## OKLAHOMA OSTEOPATHIC HOSPITAL

This is in support of the application for the teletherapy license for Oklahoma Osteopathic Hospital submitted on February 10, 1988 (control number 461842). You may recall I called you on May 5, 1988 and you said we could have an extension on the 30 day time limit for reply indicated in your letter. In particular, we reply to your questions dated March 25, 1988.

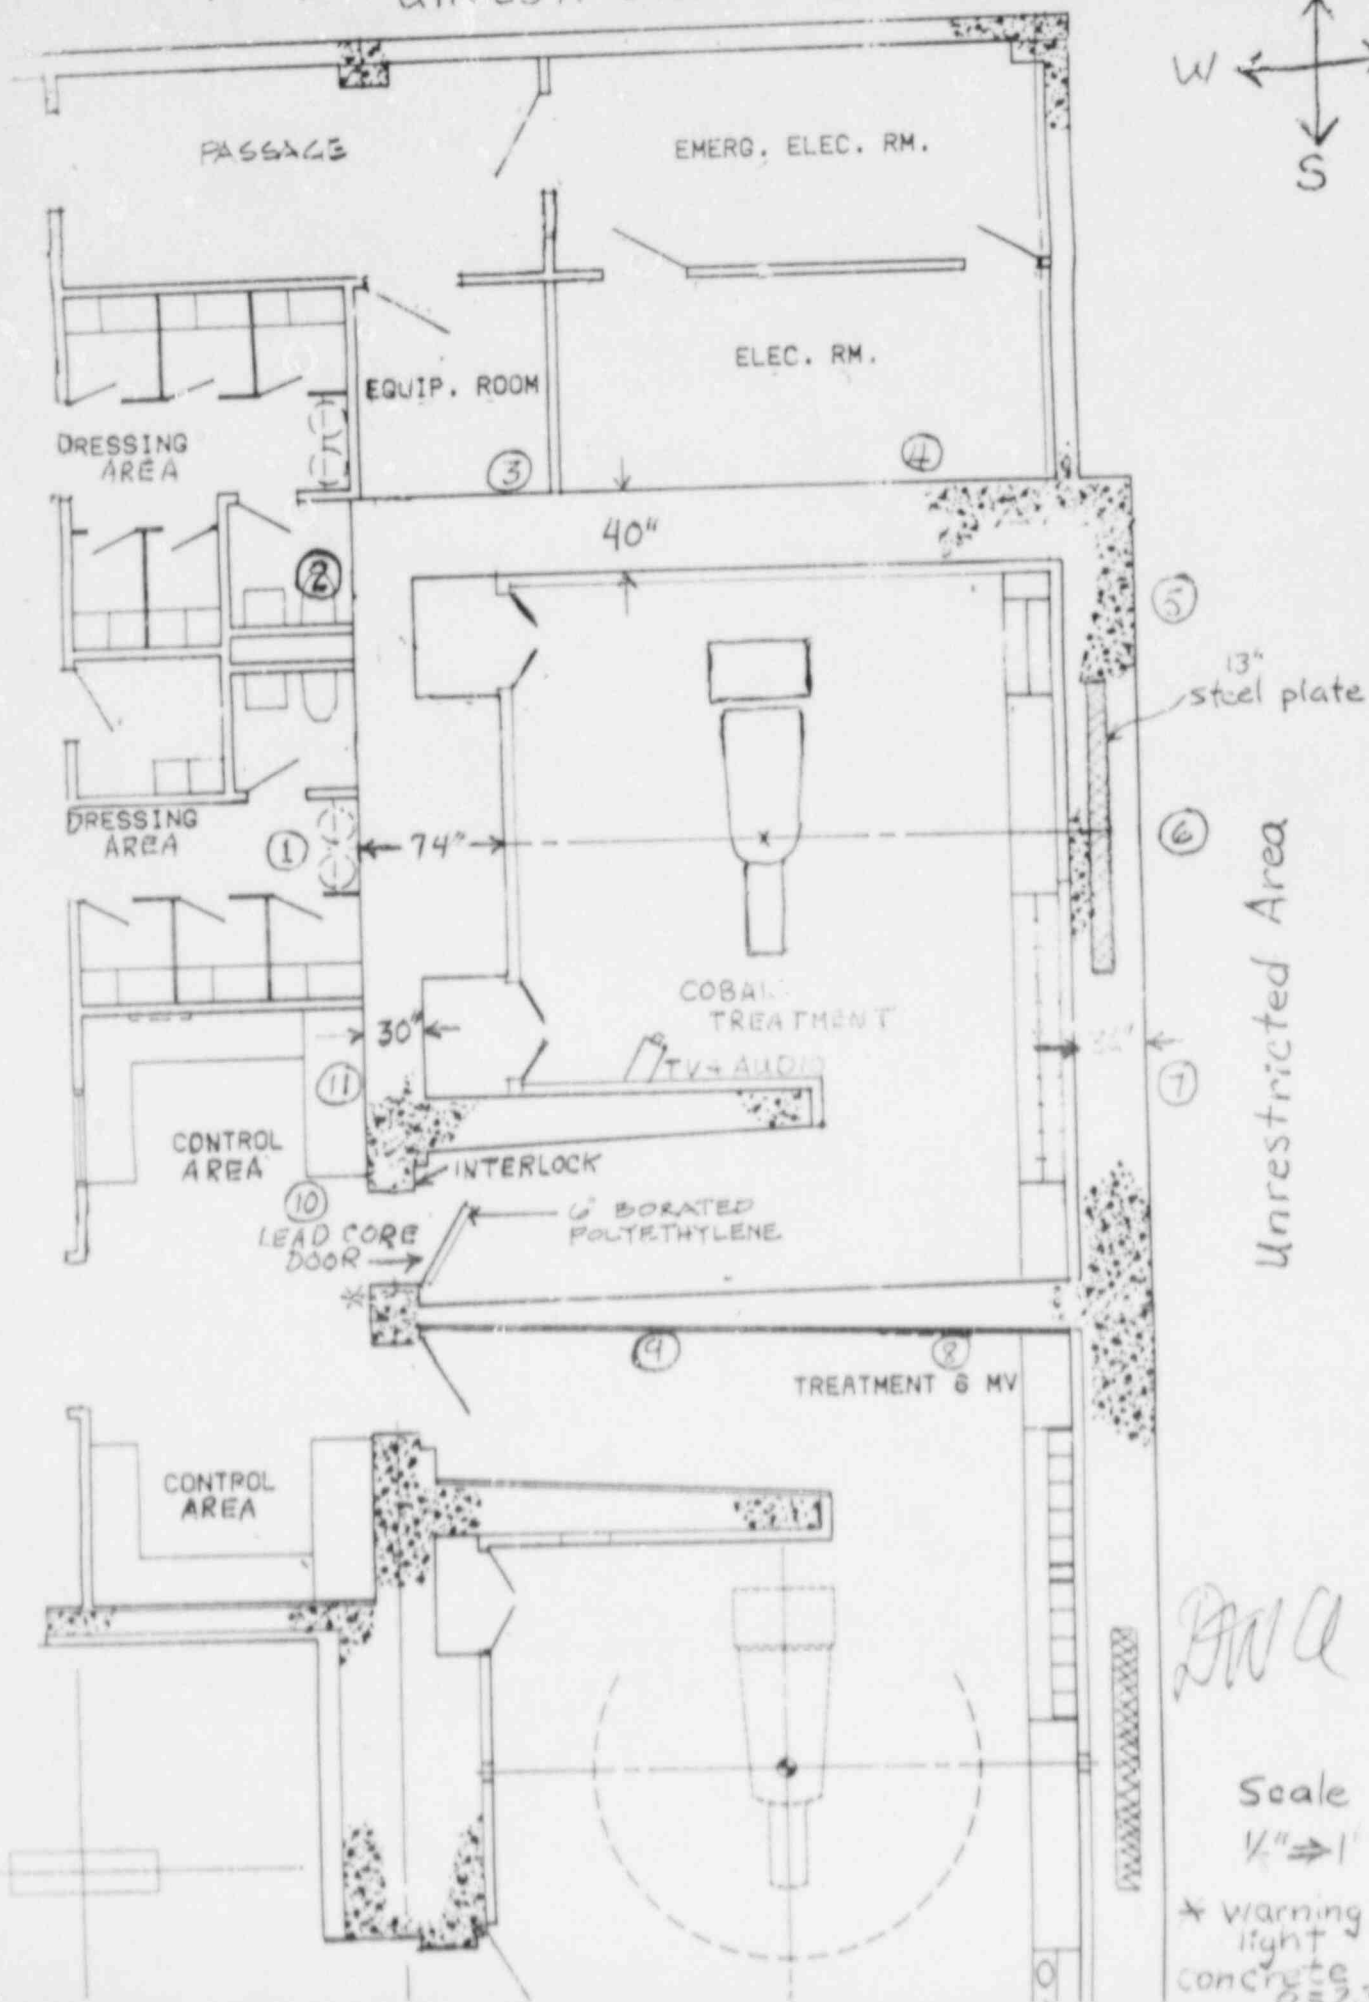
6. The walls were designed so the only penetrations through them are behind the maze, above the entrance doorway, at about 12 feet above floor level. The scatter load at the end of the maze is expected to be about 2 mrem/wk (as shown on the calculations for position 10 ). The radiation level at normal height above the floor will be increased by a small fraction of this and much less than the allowed maximum permissible doses at these restricted positions.

8. The teletherapy unit is equipped with electrical interlocks which can be set to restrict the angle of rotation of the beam away from the backstop. The electrical interlocks will be set to allow radiation at lateral directions with the head rotated away from the backstop by as much as  $\pm 91^\circ$ . The electrical system will be set so the head cannot be rotated front to back by more than  $\pm 2^\circ$  (nominal) from the backstop. This is as stated in 9.4. Note the calculations indicate the shielding is adequate for this operation (specifically at positions 1 and 6 ).

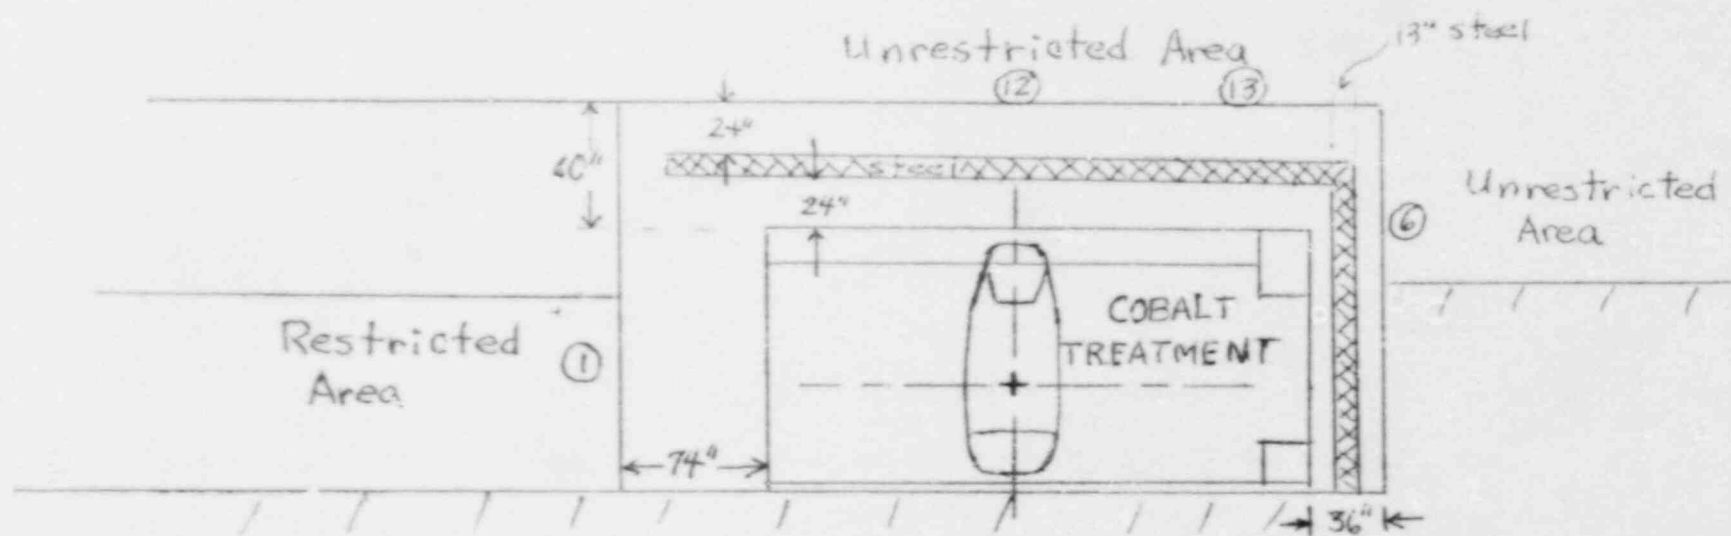
4. Apparently the elevation view was not enclosed in the copy sent to the NRC. I apologize and it is now attached after the plan view. Much of the information requested was on that drawing. The ceiling shielding includes at least 48" of solid concrete with an additional 12" thick steel beam stop strip 12 feet wide directly above the gantry head and extending laterally. The shielding is designed to be sufficient for (sometime in the future) a 20 MV accelerator which would have no back stop. The radiation levels on the roof are shown at positions 12 and 13 (see elevation view) on the calculation pages as less than 0.001 mrem/week with maximum rate of less than 0.01 mrem/hr above background.

5. The height of dirt against the outside wall is indicated on the elevation view as approximately 9 feet above the floor level. A 6" thick concrete floor with solid dirt fill is also shown on the elevation view. There is no access available under the floor.

7. The question would have been answered if the elevation view had been included earlier. Please note from this view that the steel plating will be the primary beam stop section when the cobalt machine is replaced by an accelerator. A steel strip 12 feet wide and 13" thick centered on the beam axis runs from floor to ceiling up the east wall and a strip 12" thick and 12 feet wide runs across the center of the ceiling. The west wall is very thick concrete (74") and no steel is needed.
